Thor Motor Coach Recall Repair Instructions

Recall #	25V-653 2025-519		
Description/Title:	LP Tank Bracket		
Affected Product Line(s):	Certain MY 2024-25 Indigo & Luminare		
Service Campaign # :	RC000331		
Repair Code:	Inspect with Repair: TMCRC10120V	Document Date:	10/28/2025
Time Allowed:	Inspect with Repair: 2.0	Document Revision:	A

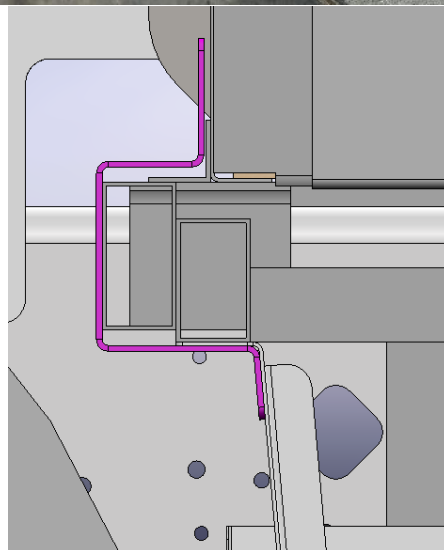
3. Position the rear (left) bracket (shown in magenta color) from the side of the truss facing the wheels. The edge of the bracket should be approx. 10" from the end of the truss. The longer flange should be to the top.

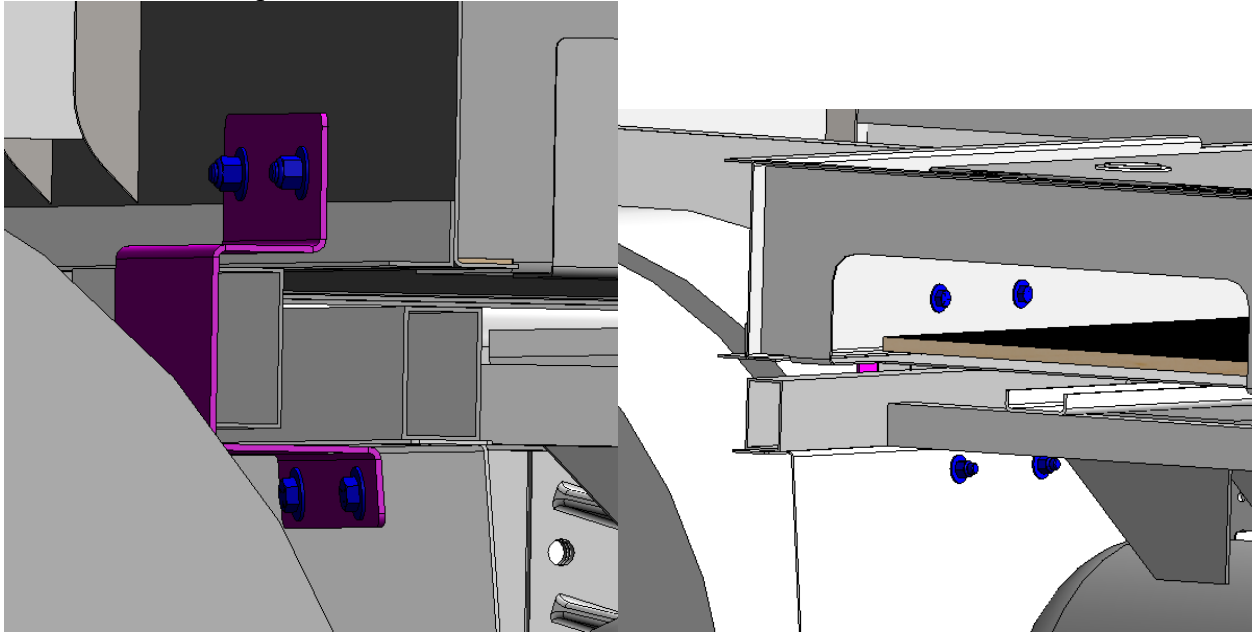
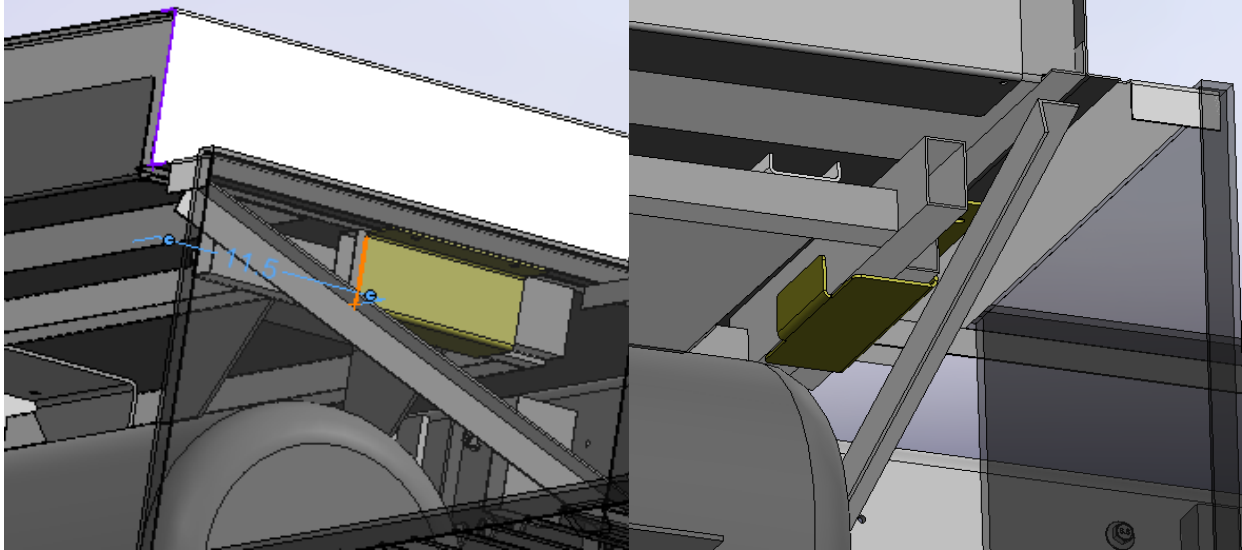
- Using the bracket as a template, mark the hole positions on the truss and debris shield. Drill clearance holes for a 3/8" bolt at these positions. **Be careful not to damage any components/water lines on the opposite side of the truss. May need to strap up the water lines out of the way.** Secure bracket at these locations using 3/8"-16 x 1" Grade 5 hex bolts, washers, and locknuts. Nuts, bolts, and washers shown in blue in the images below. Torque to 30ft.lbs.

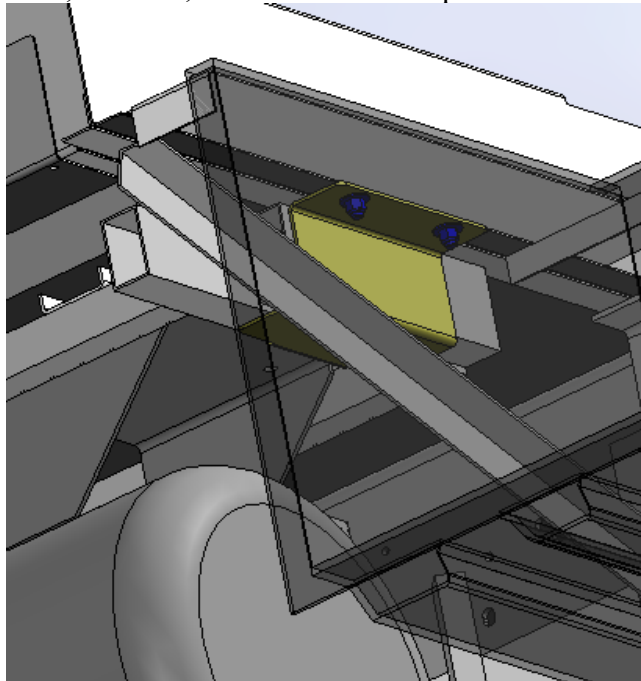
5. Position the forward (right) bracket (shown in yellow color) so that it hooks around the tubes supporting the LP bracket. The flange with the holes should meet the bottom of the truss flange above. The edge of the bracket should be approx. 11"-13" from the end of the truss.

6. Using the bracket as a template, mark the hole positions on the truss. Drill clearance holes for a 3/8" bolt at these positions. Secure bracket at these locations using 3/8"-16 x 1" Grade 5 hex bolts, washers, and locknuts. Torque to 30ft.lbs.
